**FOUR CORNERS POWER PLANT
Lined Ash Impoundment,
Lined Decant Water Pond,
Combined Waste Treatment Pond,
Upper Retention Sump, and
Dry Fly Ash Disposal Area**

**Annual
CCR Impoundment and
Landfill Inspection Report
2016**

**GENERATION ENGINEERING
Design Engineering
P.O. BOX 53999
PHOENIX, ARIZONA 85072**

20161018 – IMG_1889
 Areas of newer erosion rills along the LDWP South Embankment.

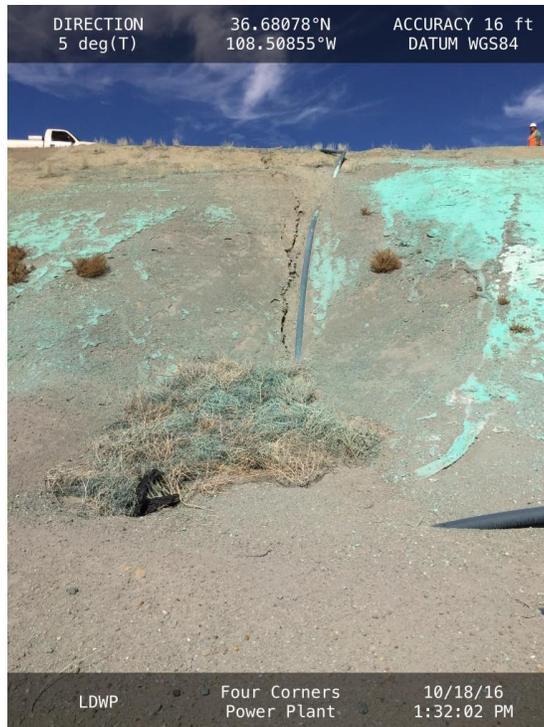
- iii. The external slopes of the embankments show evidence of minor erosion rilling (see photo IMG_1889). APS has been maintaining affected areas by regrading and recompacting eroded areas (see photo IMG_1914). At the time of the inspection, several locations along the South Embankment had recently been repaired. The current program appears to be sufficient and should be continued such that rills are repaired if the erosion depth exceeds one foot.

20161017 – IMG_1447

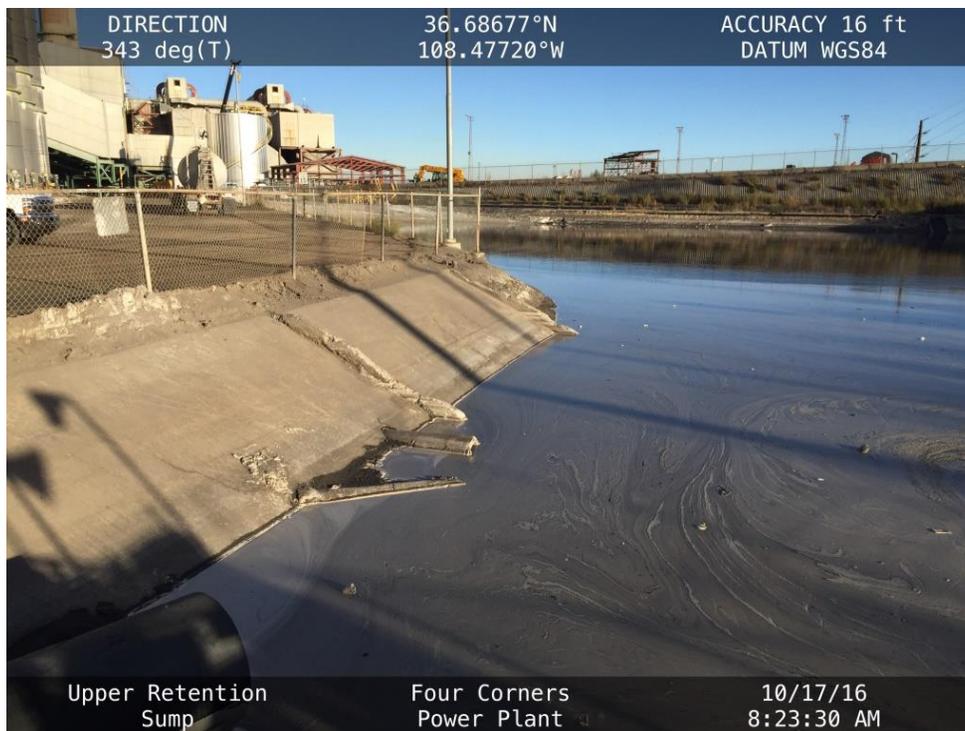
- ii. The current pond level allowed a visual inspection of the concrete access ramp along the North Embankment. There was a noticeable degree of undermining beneath the ramp (see photo IMG_1447). Consider repairing this area.

- iv. Accumulated solids in the Upper Retention Sump are periodically removed after dewatering the pond with excavation and haulage equipment. There is an access ramp in the northwest corner of the Upper Retention Sump (see photo IMG_1447).

Observed Condition	Action Item
1) Monitor the erosion in the northeast corner.	This will be an ongoing maintenance requirement.
2) The canal and associated drain pipe feeding into the Upper Retention Sump were clogged at the time of the inspection.	APS was in the process of cleaning the canal and pipe during the inspection. This will be an ongoing maintenance requirement.
3) The access ramp in the northwest corner of the unit appeared to have been undermined.	Continue to monitor the undermined area and repair or replace if determined necessary.

20161017 – IMG_1620

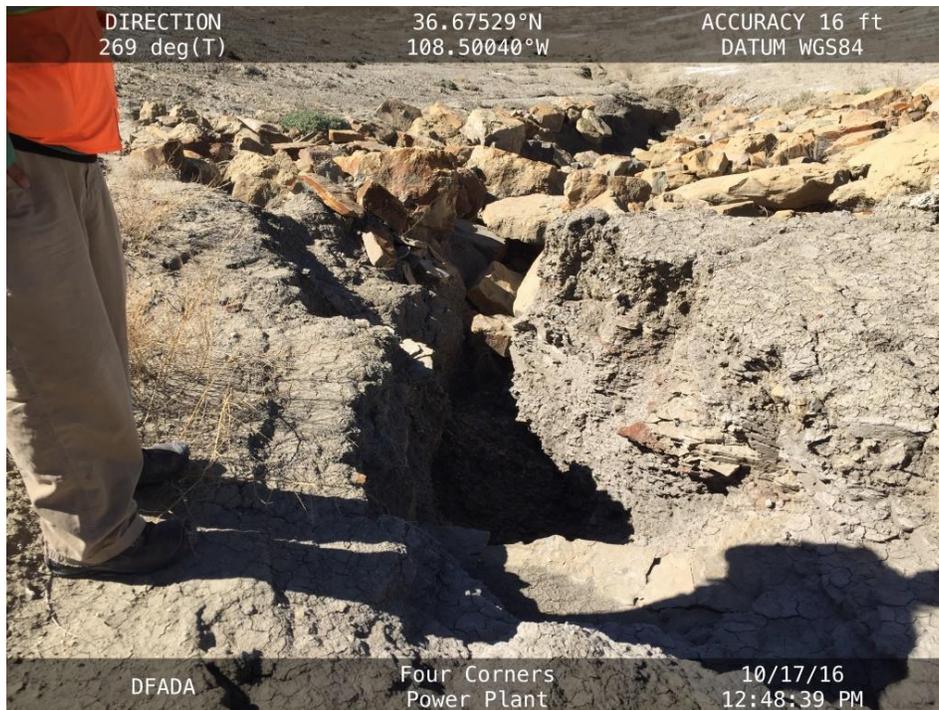
- ii. The eastern slope of Cell 2 appears to be graded to an approximate 5H:1V or 6H:1V (horizontal : vertical) slope angle (see photo IMG_1620). Internal slopes are approximately 2H:1V. At the time of the inspection, Cell 1 was at a higher elevation than Cell 2 and CCR solids (ash) were being placed in Cell 3 (see photo IMG_0095).
